# Access Compliance Report

## Public Rights-of-Way

Intersection ID: N/A	Main Street: TROJAN_DR	Cross Street: OUTLETS_BV	Location: W
ADA ID: 6FF475169626	Ramp Type: PerpDiag	Initial Pass/Fail: Fail	Overall Compliance: No
			Severity Score: 33.75

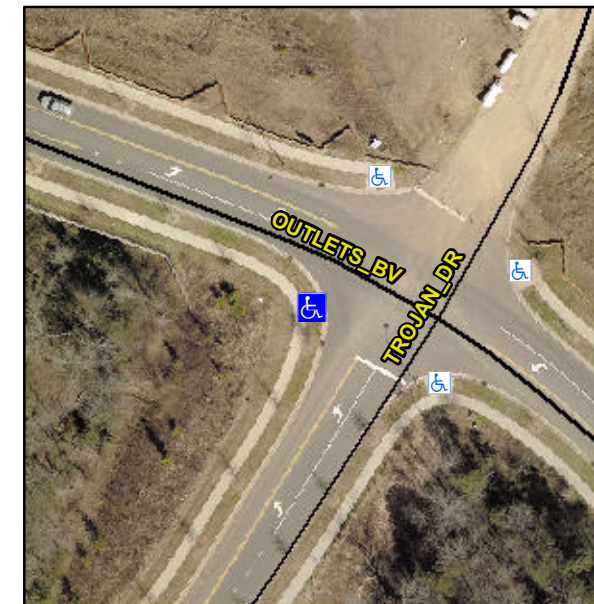
**Not Found, R304.5.1, R304.2.2**

Compliance	Description	Data	Compliance	Description	Data
N/A	Ramp Length (in)	96.0	No	Ramp Slope (%)	12.0
No	Ramp Width (in)	46.5	Yes	Ramp XSlope (%)	0.2
N/A	Flare Type LT	N/A	N/A	Flare Type RT	N/A
N/A	Flare Slope LT (%)	N/A	N/A	Flare Slope RT (%)	N/A
N/A	Flare Traversable LT?	N/A	N/A	Flare Traversable RT?	N/A
N/A	Landing Length (in)	N/A	N/A	DWS Provided?	N/A
N/A	Landing Width (in)	N/A	N/A	DWS Contrast?	N/A
N/A	Landing Slope (%)	N/A	N/A	DWS Length (in)	N/A
N/A	Landing X Slope (%)	N/A	N/A	DWS Full Width?	N/A
N/A	Landing Curb? (Y/N)	N/A	N/A	DWS Offset (in)	N/A
N/A	Shared Landing?	N/A			
N/A	Gutter Ponding?	N/A	N/A	Gutter Slope (%)	N/A
N/A	Gutter Lip Ht (in)	N/A	N/A	Gutter X Slope (%)	N/A
N/A	Painted X Walk1?	No	N/A	Painted X Walk2?	No
	X Walk 1 Direction	To SE		X Walk 2 Direction	To NE
N/A	X Walk 1 Width (in)	N/A	N/A	X Walk 2 Width (in)	N/A
	X Walk 1 Slope (%)	0.8		X Walk 2 Slope (%)	0.2
	X Walk 1 X Slope (%)	0.5		X Walk 2 X Slope (%)	1.5

**Remove & Replace Curb Ramp With Two New Directional Ramps or Equivalent.**
